25130

Response to Submissions | Response to Test of Adequacy Comments 2 and 2A Bullecourt Avenue (SSD-97092958)

Figure 2 Bulk Earthworks Plan

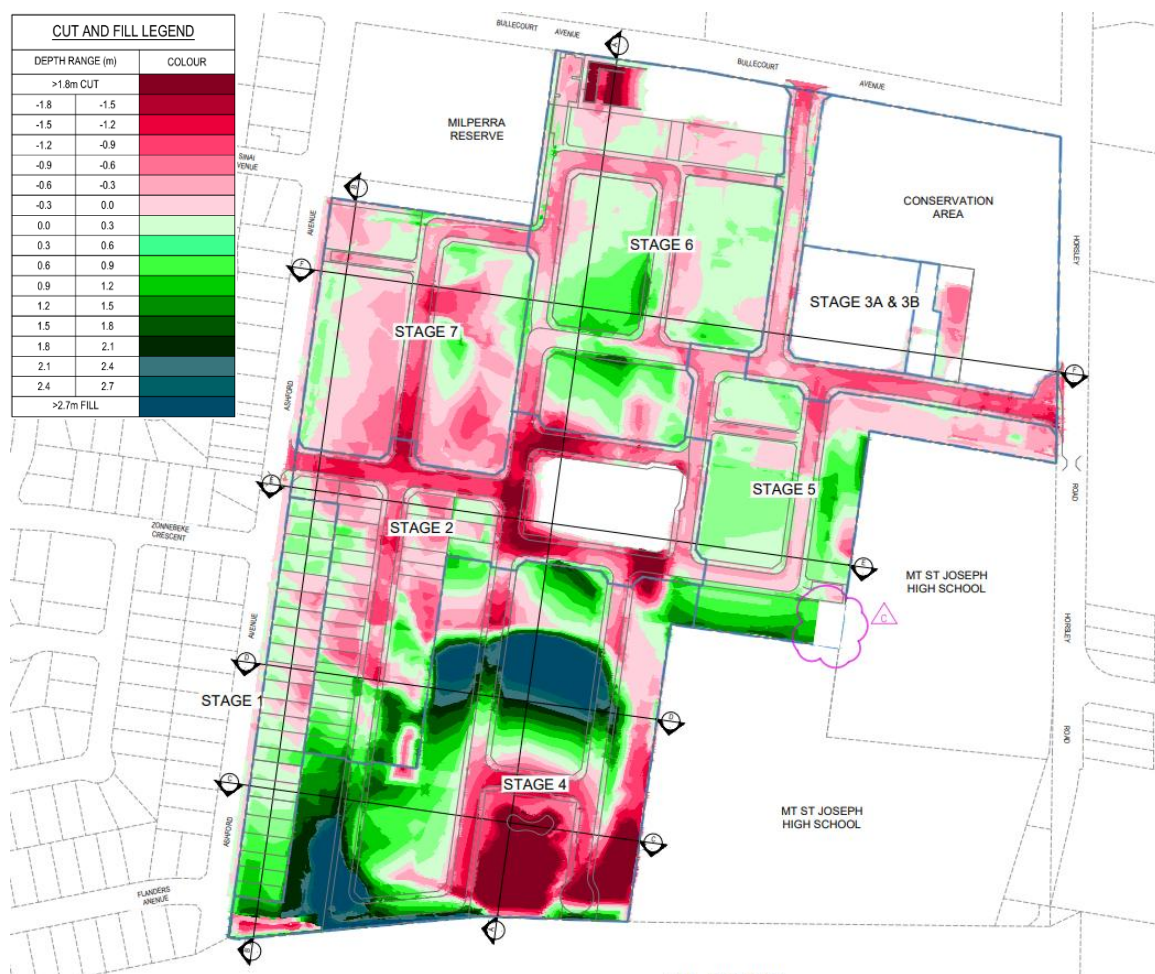
After a review of the additional information submitted, further justification is required on the avoidance of impacts to biodiversity outside of the C2 zoned land. The justification provided to the department seeking reliance on compliance with the DCP, as well as engineering matters, are insufficient to demonstrate that all reasonable actions have been implemented to avoid impacts upon the Cumberland Plain Woodland community. Further information is required for assessment, which may result in a change to lot numbers, including the consolidation of a number of lots to retain vegetation, for Stages 3 onwards. This could result in larger lots subject, which would be subject to future DA's for assessment. Attachment A indicates areas of vegetation that could be retained (outside the identified areas of contamination), however there may be other alternatives for retention of the vegetation.	Further consideration has been given to the avoidance of CPW outside the C2 zone which has resulted in additional opportunities being implemented for the retention of CPW Trees 217, 56, 400, 403 and 408. Additional investigations into the other CPW trees identified in Attachment A of the Department's letter has revealed that Trees 85, 108, 275 and 276 were originally assessed as having existing areas of decay. Following storm damage experienced in January 2025, the trees have now been assessed as having a short useful life expectancy and may present a danger to future residents in the form of dropping limbs. Given their deteriorated condition and limited retention value, retaining these trees is not considered warranted, particularly where doing so would require the removal of residential dwellings from the proposed development.

The Central Park area, where separate soil remediation is required, is proposed to be retained at existing ground levels. This differs from the Case Study 2 area, where both remediation and substantial earthworks are required to achieve a suitable development platform.

The need for bulk earthworks arises from existing topographical constraints across the site, which currently result in poor stormwater drainage and suboptimal lot configurations. Earthworks will therefore be undertaken to establish appropriate levels, improve drainage outcomes, and create functional residential lots.

Consultation with the project arborist has confirmed that trees cannot be retained where more than 200 mm of fill is required within their root zones. Given the extent of excavation, soil replacement, and filling required in the Case Study 2 area, it is unlikely that existing CPW trees would remain viable. The necessary compaction and disturbance of the root zone would significantly compromise tree health.

In order to further avoid the loss of CPW across the site, a revised design has been prepared which amalgamates lots to facilitate a bulk earthworks plan that can safely retain 7 existing CPW trees in Stages 5 and 7. The redesign results in a retention of 7 additional CPW trees and by reducing the total number of lots in Stage 5 by two, and one lot in Stage 7.

Figure 3 Case studies

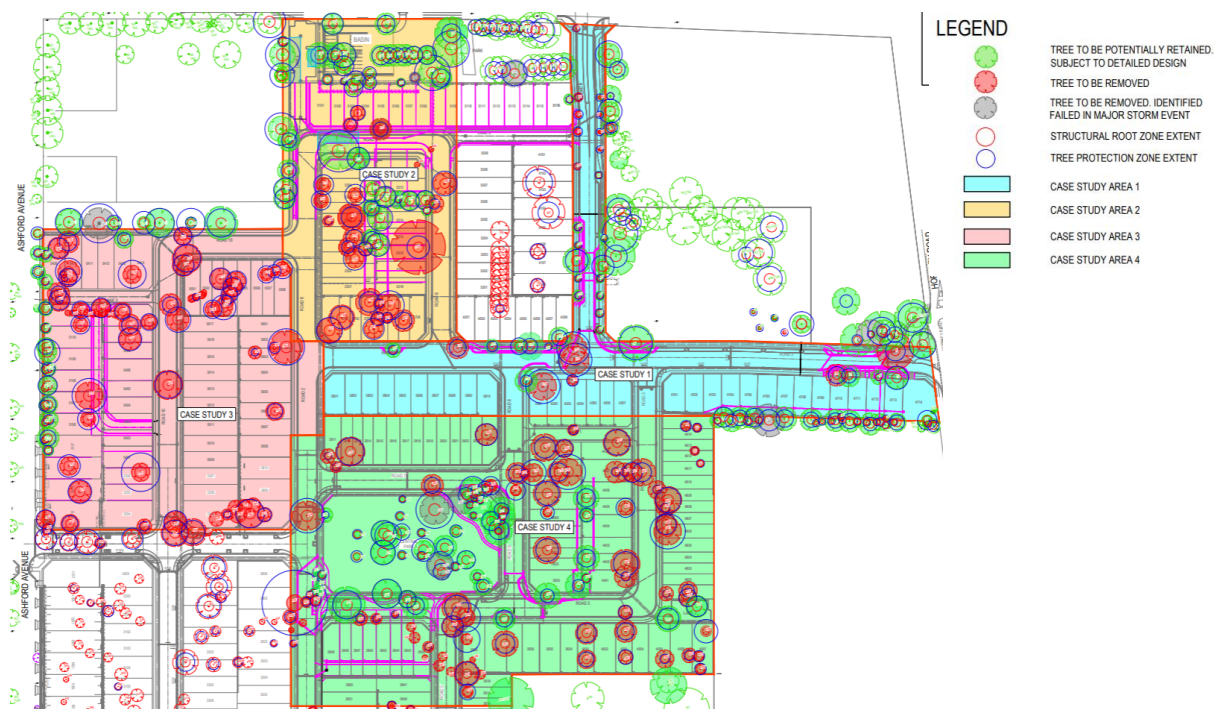
ToA Comment	Response
Comments provided on 10 April 2026	
Please provide details of alternative subdivision designs retaining Cumberland Plain Woodland within the proposed road, lot and open space network to demonstrate that avoidance of impacts across the broader site has been considered.	Further demonstration of avoidance of impacts to the Cumberland Plain Woodland (CPW) is provided within this letter below, including opportunities to avoid the removal of additional CPW tree species. Alternative subdivision designs explored are not limited to only CPW, but all trees, as shown in the case studies discussed in Section 4 .
Please confirm the amount of vegetation being removed and the area of CPW being affected. Section 9.1 (p. 115) refers to a total of 0.80ha being impacted, but the subsequent tables (Tables 25 and 31) that outline removal and offsetting do not add up to this.	The Biodiversity Development Assessment Report (BDAR) has been updated to clarify the amount of CPW being removed, being 0.52 ha. The BDAR is attached at Appendix D of the RtS Report.

This section presents the four case studies shortlisted through the design development process, which occurred over a two-year period following rezoning (refer **Figure 3**). Each case study examines specific design responses within defined areas, illustrating alternative subdivision layouts that were tested as well as other minor refinements which would retain vegetation. Of these, Case Study 2, encompassing the largest intact area of CPW vegetation, was the primary focus of this analysis.

As a result of this exercise, an additional three CPW trees were able to be saved by the deletion of car parking bays located at the western side of Road 8 (within Case Study 2).

This exercise explored the retention of an additional 53 CPW trees, however, did not identify a viable alternate outcome. As part of the RtS, these options were revisited and again found to be unviable, reinforcing the extensive work undertaken across multiple planning stages to explore opportunities to retain CPW. Ultimately, the process confirmed that the proposed development has maximised the retention of CPW across the site.
